Land West of Ratby

Pell Frischmann Response to ATE Comments  
109003

Project	Land West of Ratby
Document Title or Subject	Pell Frischmann Response to ATE Comments
Document Reference	109003-PEF-ZZ-XX-T.TN-H-000015
Revision Reference	S2_P2
Date	05/01/2026

Figure 1. Burroughs Road / Markfield Road - Brookvale Groby Learning Campus

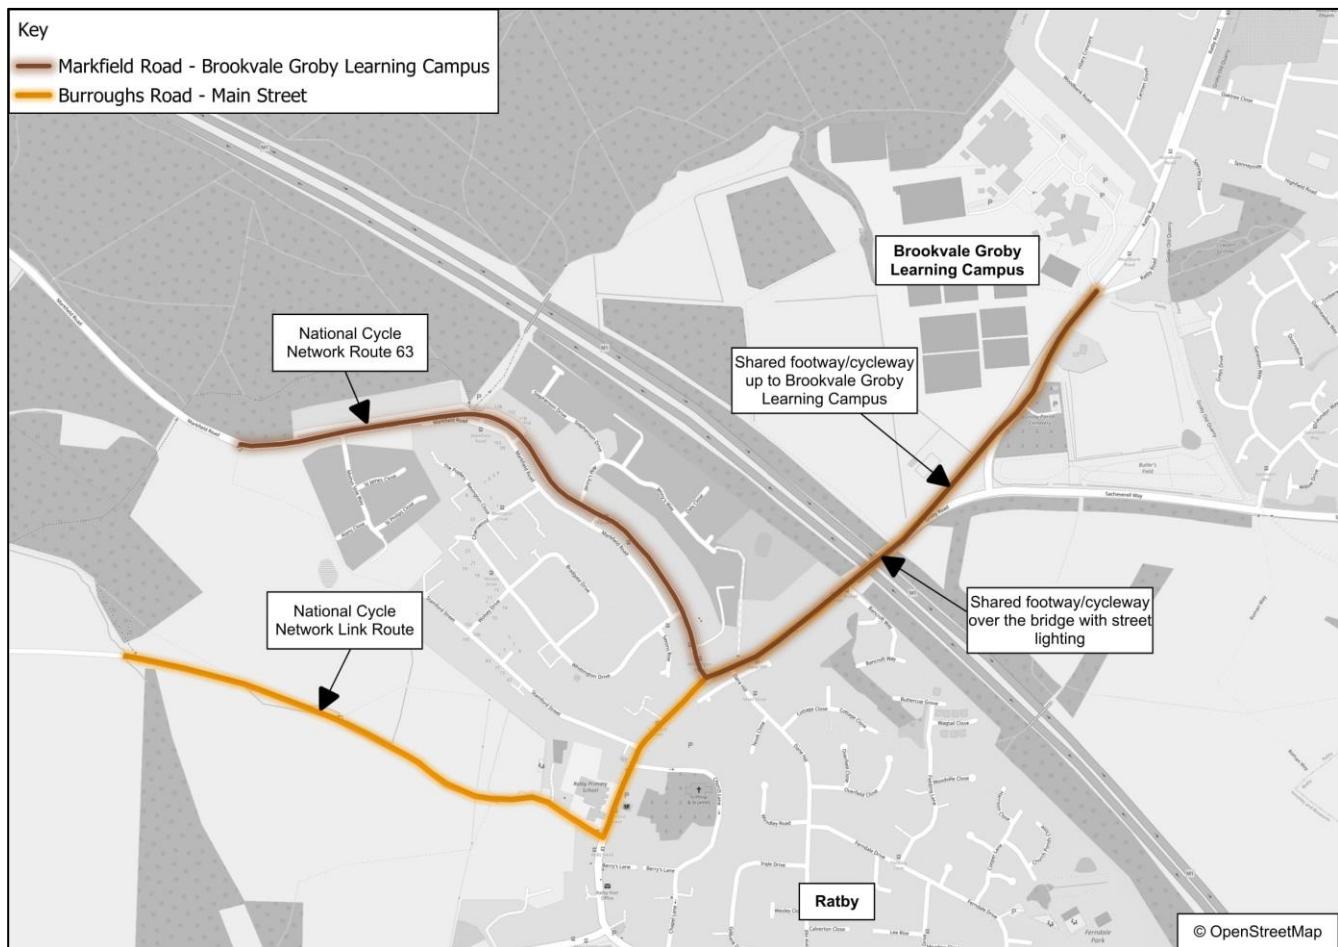
- 2.4.1 Criteria 2 of ATE Route Check Tool has been applied to two cycle routes towards Brookvale Groby Learning Centre via Markfield Road and Burroughs Road are shown in **Table 2** and **Table 3** respectively.
- 2.4.2 Please note that due to both of these routes being the same as each other except for the beginning road the route begins on, **Table 2** will assess the route from Markfield Road through to the school and **Table 3** will only assess the remaining areas (Burroughs Road and Main Street up until Markfield Road). These routes are shown in **Figure 1**.

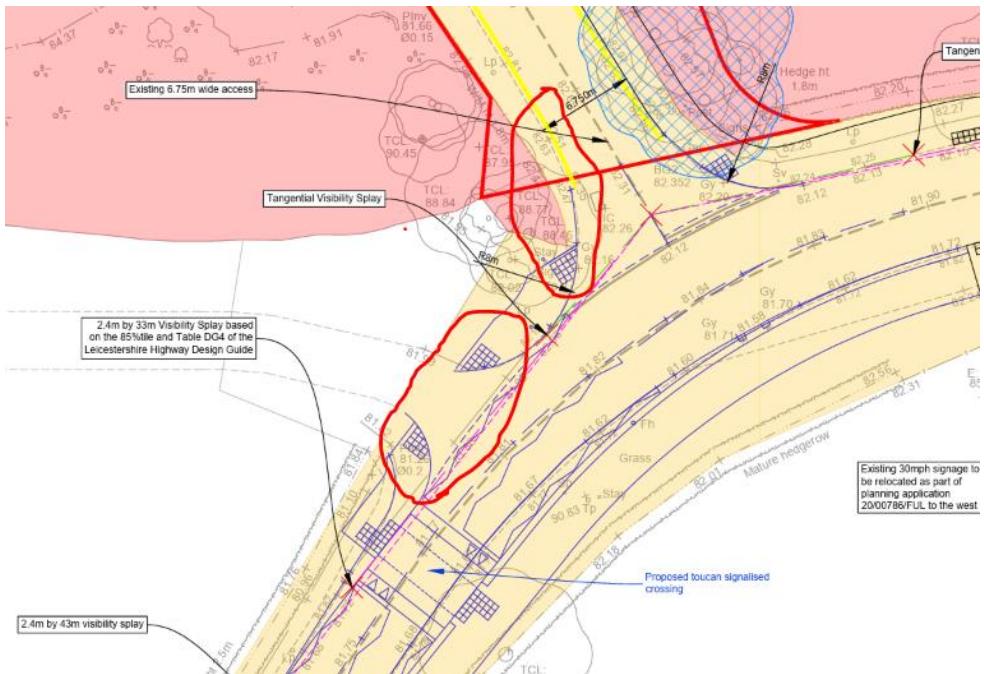
It is welcome that a new section of segregated cycling infrastructure and a new parallel crossing is now proposed inside the site as the spine road would intersect with Burroughs Road, the route likely to absorb significant active trips. This hints at a continuation of this infrastructure to the north, but disappointingly not the south. Why would trips originating this way not want this same good quality infrastructure? It remains disappointingly that at this central intersection of a residential growth area is designed around the car and not people. An opportunity for a new village green or town square would have been worth exploring.

Figure 3: Details of Desford Road scheme of mitigation as shown in Figure 13 of Pell Fischmann Transport Assessment Addendum

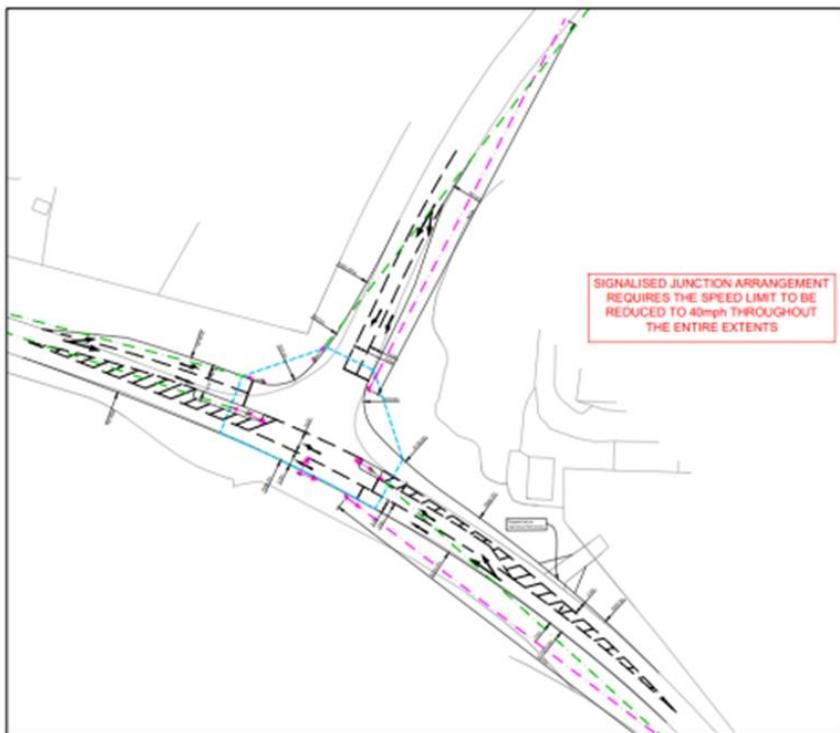
This is an existing priority junction however because of the impact of the proposed development at this junction the applicant has submitted a scheme of mitigation as shown on drawing number: 109003-PEF-ZZ-XX-DR-TR-00010\_S2-P01 (Figure 3 below). This shows a redesign of the current layout with a new three arm signalised junction arrangement with two lane approaches on all arms. The applicant has also indicated that the scheme requires the speed limit to be reduced to 40mph throughout the entire extents. This would be subject to a separate process outside the planning arena if permission is granted and would be subject to a formal consultation period as part of that process.

The junction model was subsequently updated with the revised layout and the applicant has concluded that the predicted results of the modelling (shown below in Figure 4) predict that the highway improvement scheme would mitigate the impact of the proposed development.
